**Historic Area Commission Special Meeting  
Community Room New Castle City Police Station  
1 Municipal Blvd., New Castle, DE 19720  
Tuesday, October 21, 2025 – 6:30 p.m.**

1. 23 W 6<sup>th</sup> St – Larry Kouma – Solar panel installation.
2. 201 Delaware St – Trustees of New Castle Commons – Replace HVAC.

Revised Application 2 Oct 2025  
→ Shift upper roof panels away from edge

**Historic New Castle, Historic Area Commission - Solar project consult**

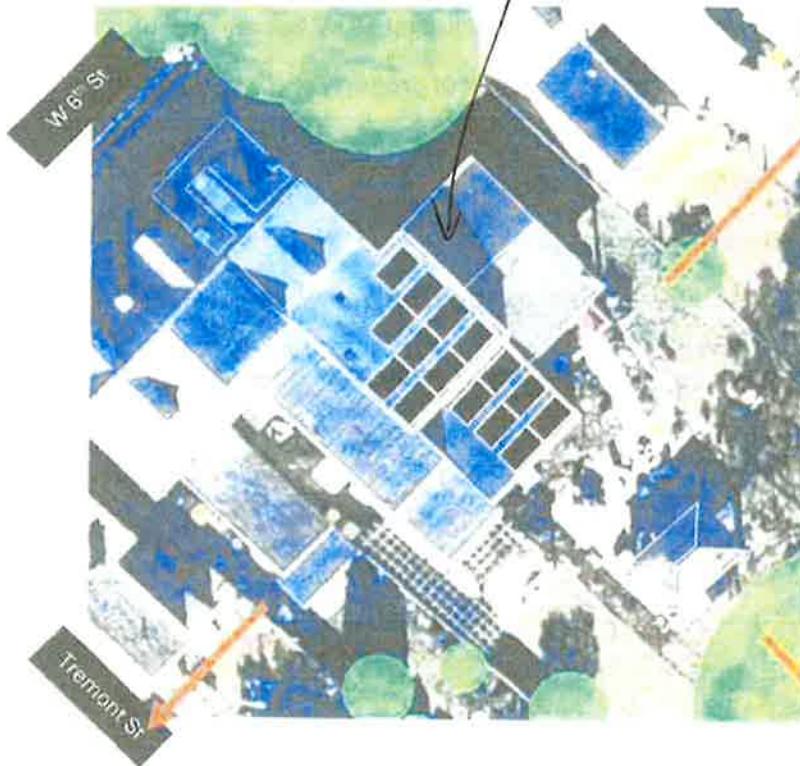
2 Oct 2025 LK

See revised w/ panels shifted away from edge

Revised w/ panels  
shifted left away from edge  
2 Oct 2025 LK

View from 23 W 6th street sidewalk across the street

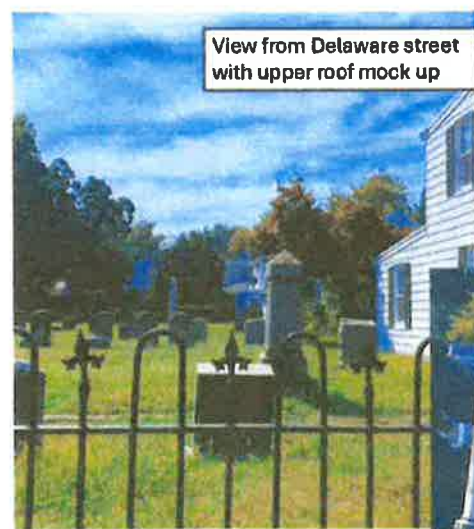
Revision - mounting flat → will not be visible 2025  
KC

Revision -  
mounting flat and  
will not be  
visible

1 panel is visible with zoom

View from Delaware street

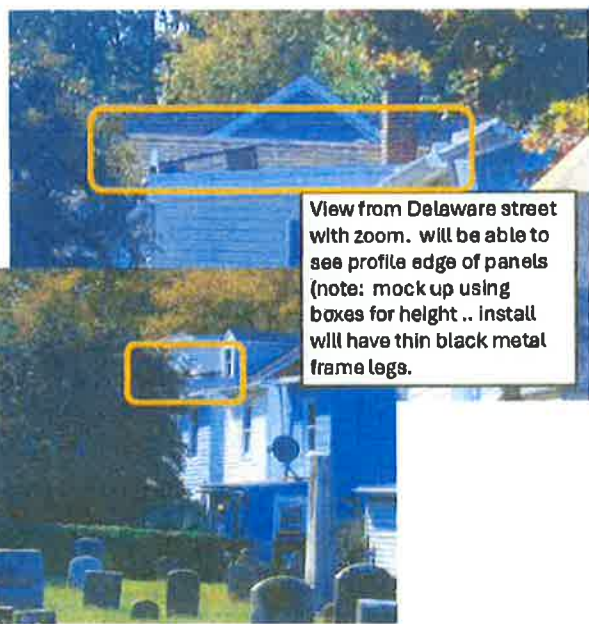
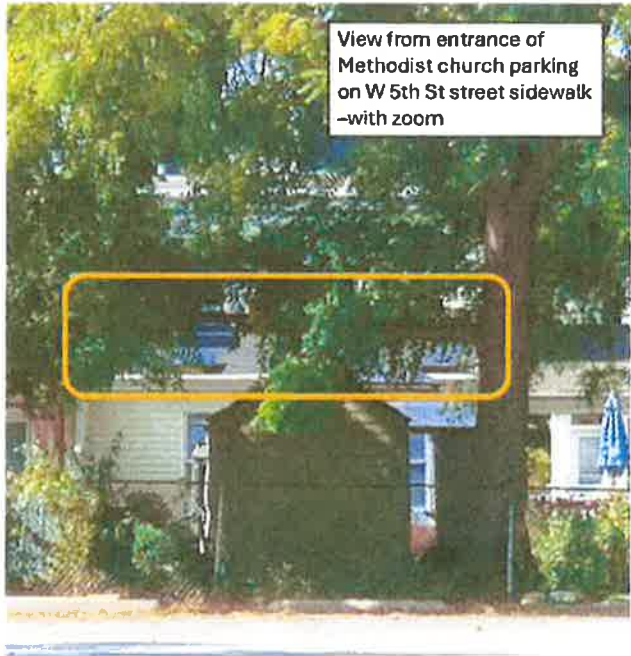
View from Delaware street with upper roof mock up

View from Delaware street with zoom. will be able to see profile edge of panels (note: mock up using boxes for height .. install will have thin black metal frame legs.

*FENCED AREA*

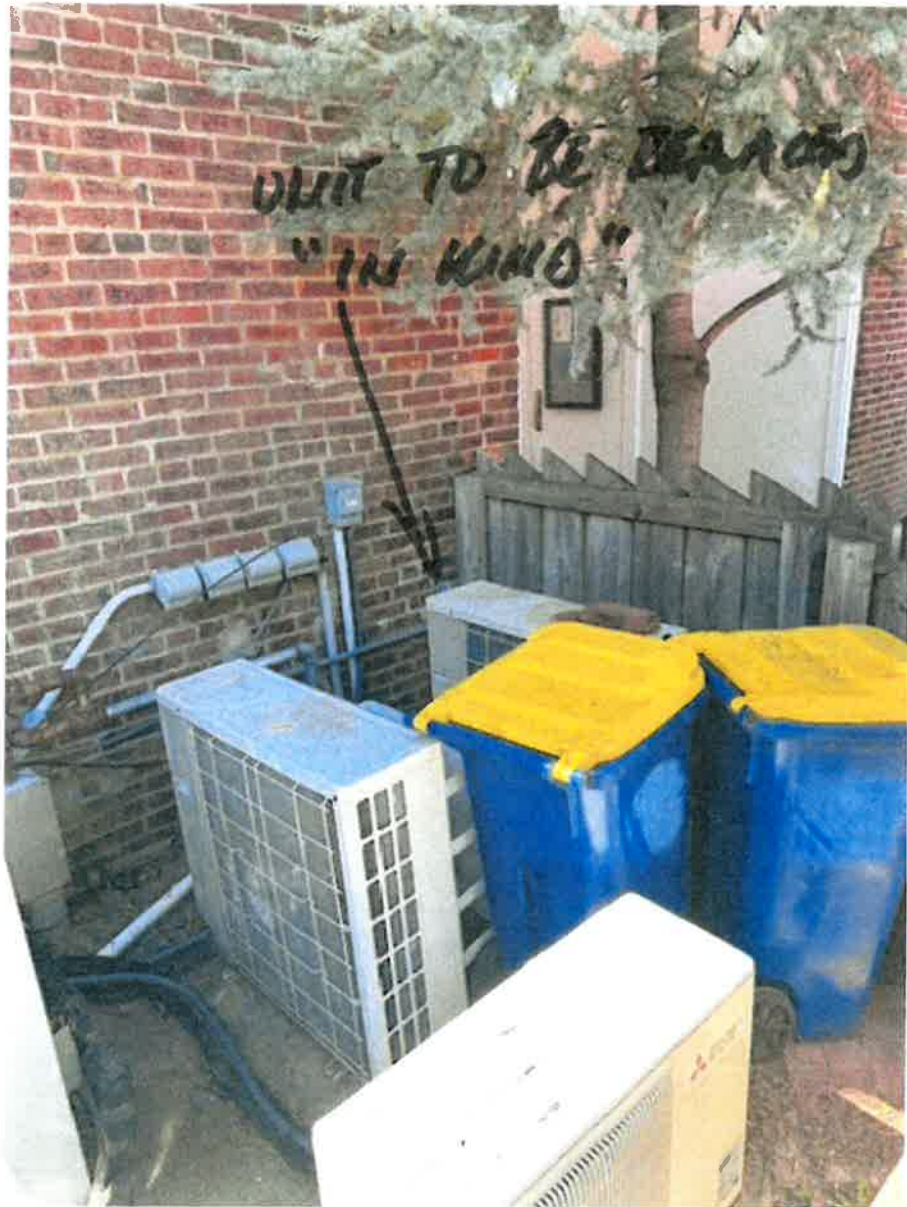
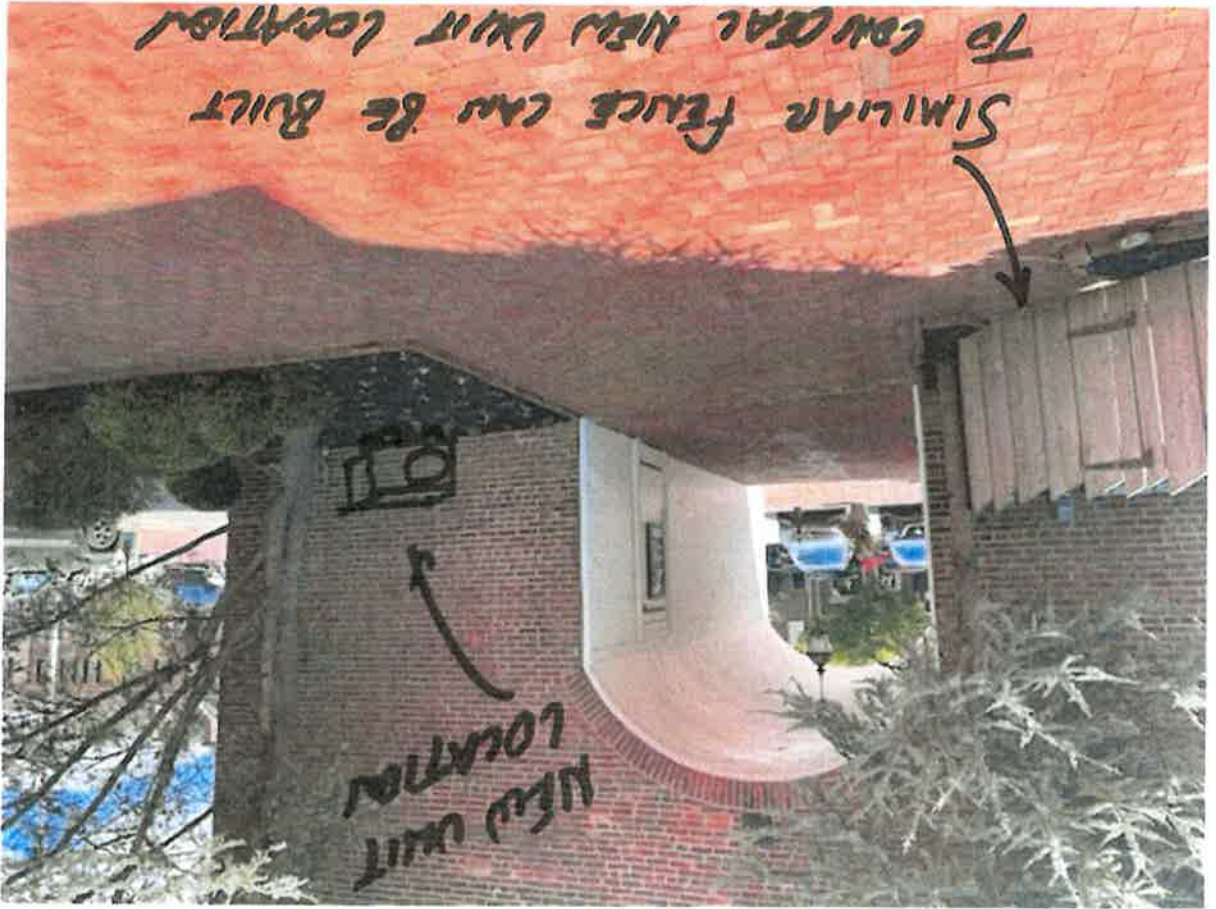
*MAYBE A FENCE CAN  
BE INSTALLED TO  
CONCEAL IT?*

SIMILAR FENCE CAN BE BUILT  
TO CONCEAL NEW UNIT LOCATION  
AS WELL AS "BALANCE" THE ENTRY
